Access Compliance Report Public Rights-of-Way (Curb Ramps)

Main Street: BRADBURY_RD Cross Street: LOS_ALAMITOS_BLVD Location: NW

ADA ID: RPRK211221112055 Ramp Type: Type 4 - Parallel Initial Pass/Fail: Fail Overall Compliance: No Severity Score: 2

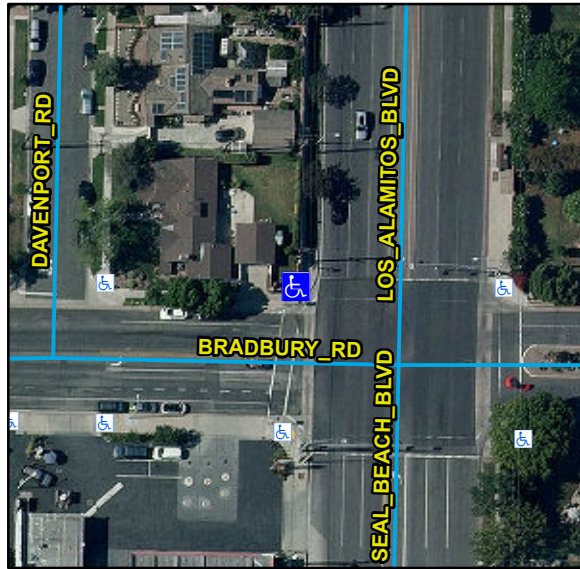
Compliance	Description	Data	Compliance	Description	Data
N/A	Ramp Length LT (in)	88	N/A	Ramp Length RT (in)	91
Yes	Ramp Width LT (in)	105	Yes	Ramp Width RT (in)	105
Yes	Ramp Run Slope LT (%)	8.1	Yes	Ramp Run Slope RT (%)	7.2
No	Ramp Cross Slope LT (%)	3.3	No	Ramp Cross Slope RT (%)	3.9
N/A	Landing Present	N/A	N/A	DWS Provided	N/A
N/A	Landing Length (in)	N/A	N/A	DWS Contrast	N/A
N/A	Landing Width (in)	N/A	N/A	DWS Length (in)	N/A
N/A	Landing Run Slope (%)	N/A	N/A	DWS Full Width	N/A
N/A	Landing Cross Slope (%)	N/A		DWS Offset Type	N/A
N/A	Landing Movement Obstructed?	N/A	N/A	DWS Offset Left (in)	N/A
	Landing Movement Type	N/A	N/A	DWS Offset Right (in)	N/A
N/A	Landing Shared	N/A			
N/A	Clear Space	Yes			
N/A	Clear Space To Crosswalk (in)	48			
N/A	Marked Crosswalk 1	Yes	N/A	Marked Crosswalk 2	Yes
	Crossing 1 Direction	S		Crossing 2 Direction	E
	Marked Crosswalk 1 Width (in)	144		Marked Crosswalk 2 Width (in)	144

Remove & Replace Curb Ramp With Two New Directional Ramps or Equivalent.

R304.5.3, STD 1115
